TO: Planning and Zoning Commission
FROM: Woodrow Muhammad, AICP Planning and Zoning Director
SUBJECT: **PUD-2-14 PRELIMINARY PLAN: CYPRESS LAKES ESTATES (FINDINGS OF FACT)**

From: Matt Zyjewski - CoC
Sent: Friday, October 24, 2014 9:44 AM
To: Jonathan Starns (jstarns@donniejarreau.com); justin@dunbarconstructionllc.com; kkennedy@gwsengr.com
Cc: David Barrow - CoC; David Ratcliff; Brandon Dodson (dagrllc@cox.net); Kathi Cowen - COC; Alison Nissen (ANissen@pecla.com); Woodrow Muhammad - COC; Natalia Gustafson
Subject: DRC Comments PUD-2-14 Cypress Lakes Estates

Re: Cypress Lake Estates
PUD 2-14
DRC Response
W.O. No. 14-144

PRELIMINARY PLAN
 OF
CYPRESS LAKE ESTATES
 PLANNED UNIT DEVELOPMENT

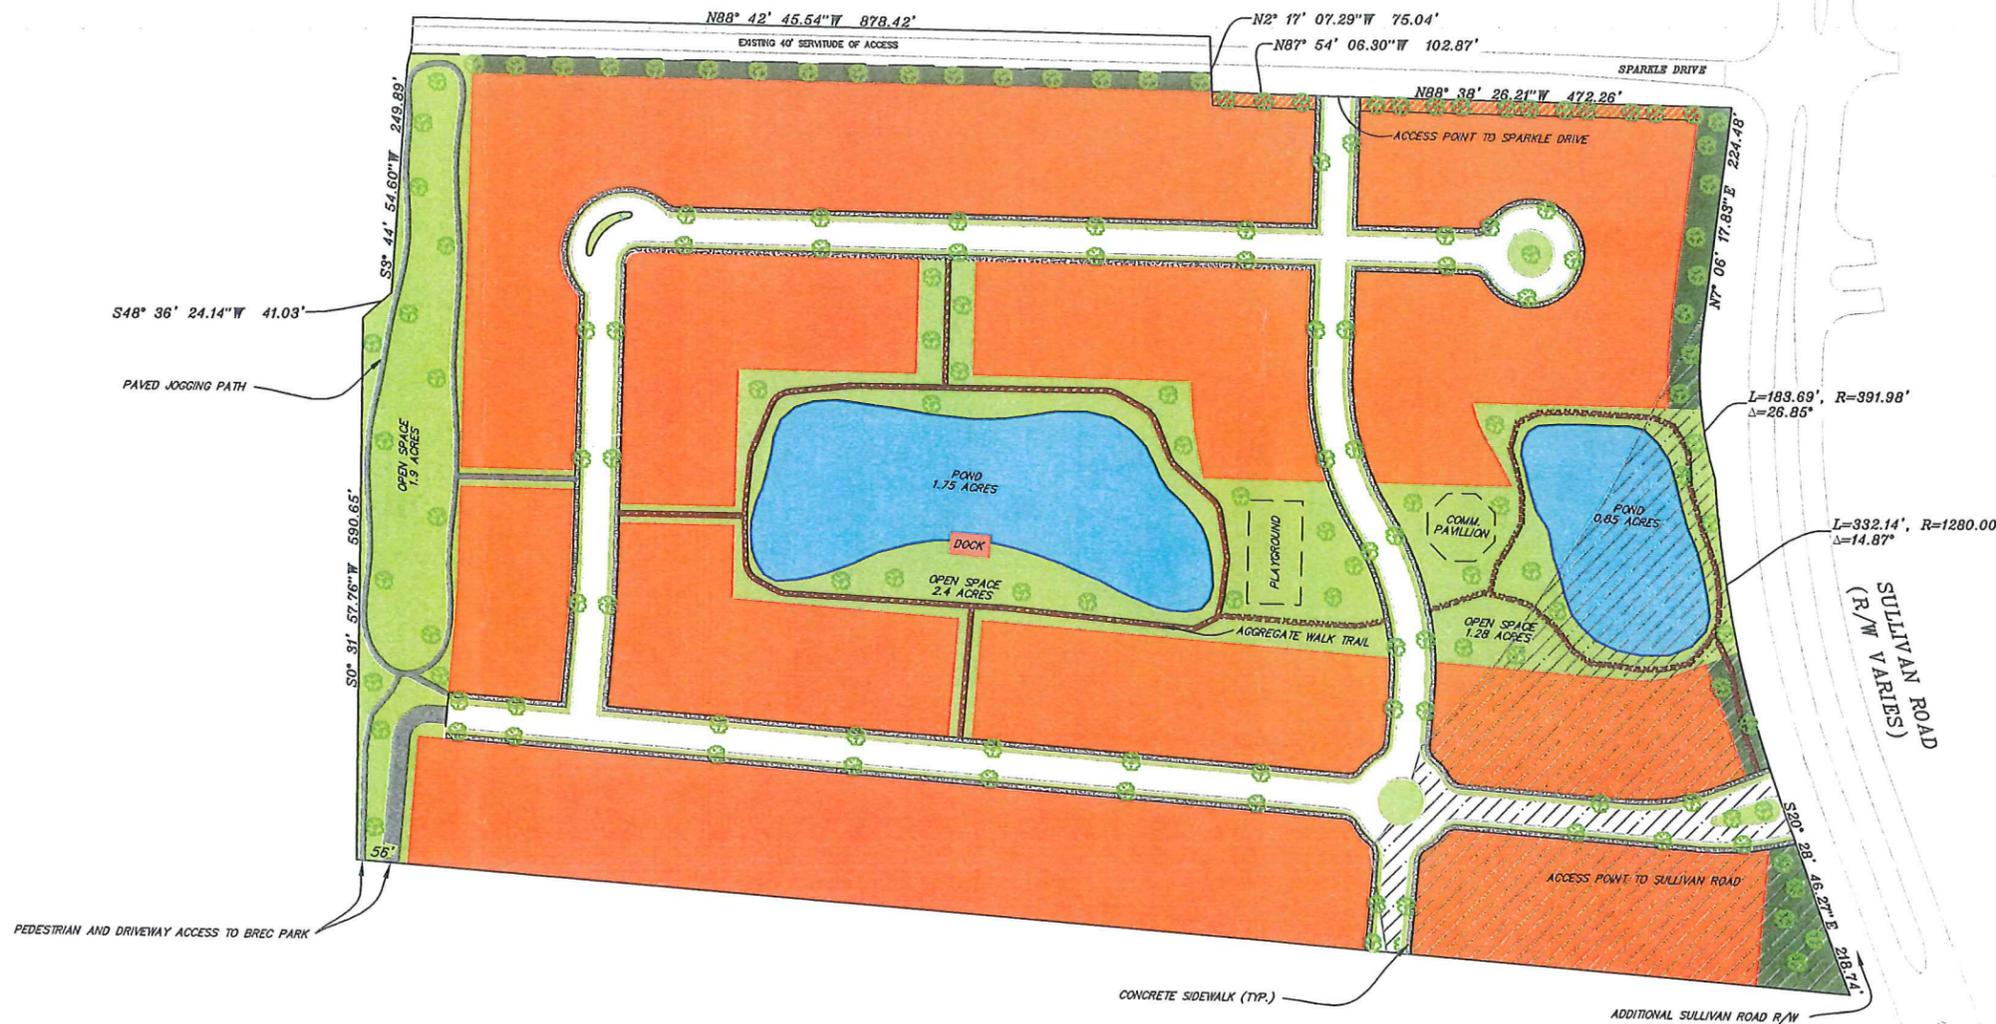
3. Double check ownership of adjacent properties with Assessor's office.
4. Update plan to show usable open space adjacent to pond.
5. Show drive/connection to BREC park.

6. Revise general notes to show R-2 Zoning.
7. Provide width of narrowest point of buffer.
8. According to subdivisions regulations, Sparkle Drive shall be improved to the Sully Road intersection.

3. All of our addresses were from the Assessor's website.
4. The dock has been added to the plan adjacent to the pond.
5. The drive connection to BREC Park has been added to our plan.

6. The general notes have been revised.
7. The width of narrowest point of buffer has been added.
8. The developer will comply.
9. The developer will consider including with required landscape improvements.

CIRCULATION PLAN
 OF
CYPRESS LAKE ESTATES
 PLANNED UNIT DEVELOPMENT

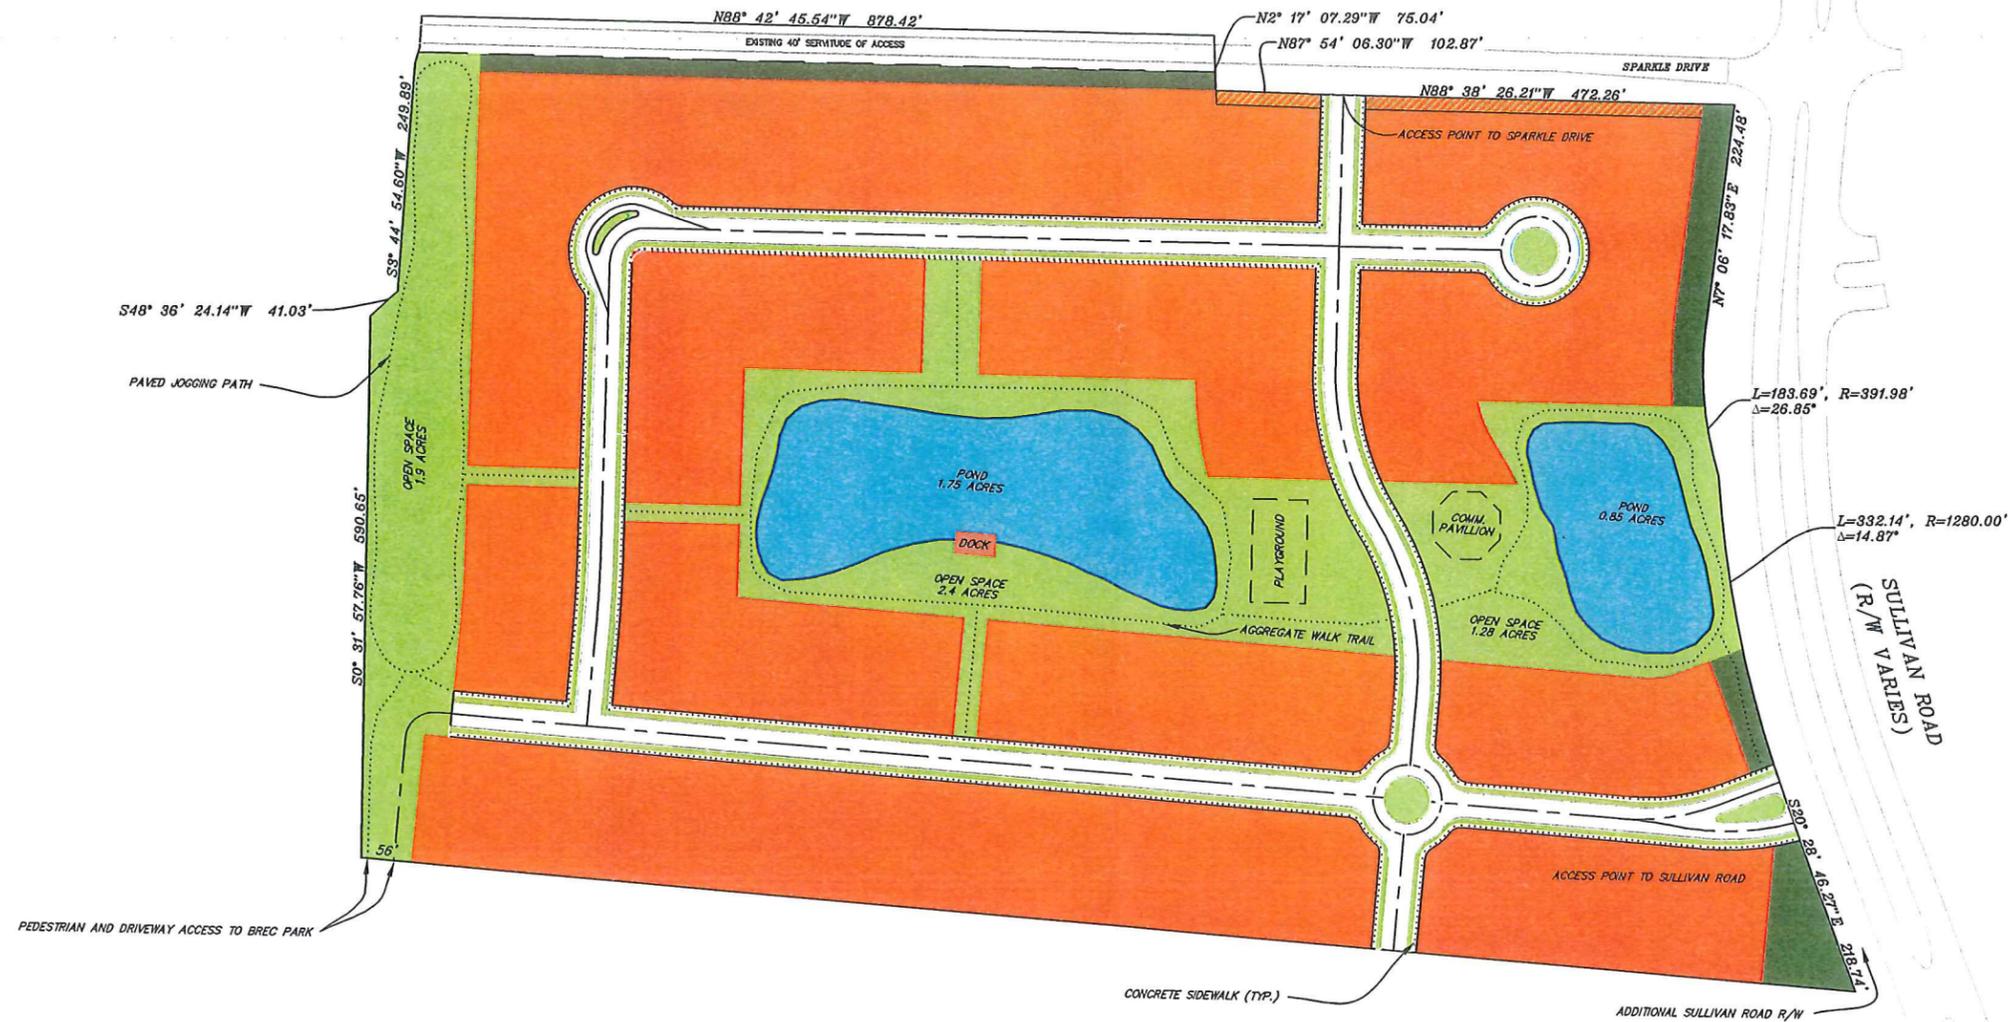
11. Sidewalks shall be installed upfront. Sidewalks must be provided adjacent to the street in any common areas/parks by the developer prior to final plat approval of each phase.

1. All construction vehicles will be required to use the entrance on Sparkle. This entrance may be reduced to right-in/right-out during construction.
2. The entrance on Sullivan will be right-in/right-out before, during and after the Sullivan widening project. No median opening will be provided. No other driveways will be allowed on Sullivan or Sparkle.
3. The actual right-of-way must be shown on the plans. The property for the widening has been purchased, so actual lines may be shown.
4. Traffic contribution of \$200 per lot paid prior to final plat signature on each phase.
5. Right-of-way of proposed streets shall be consistent with typical street sections (Appendix J of Development Code).

10. The covenant will stipulate that fences on rear yards facing ponds must be translucent, i.e. metal fencing no taller than 4'.
11. Sidewalks will be installed and have been added to the plan.

1. The developer will comply.
2. The developer will comply.
3. The right of way has been added to the plans and the boundary and acreage of the property has been updated.
4. The developer will comply.
5. We are proposed the Neighborhood Yield typical section from the UDC.
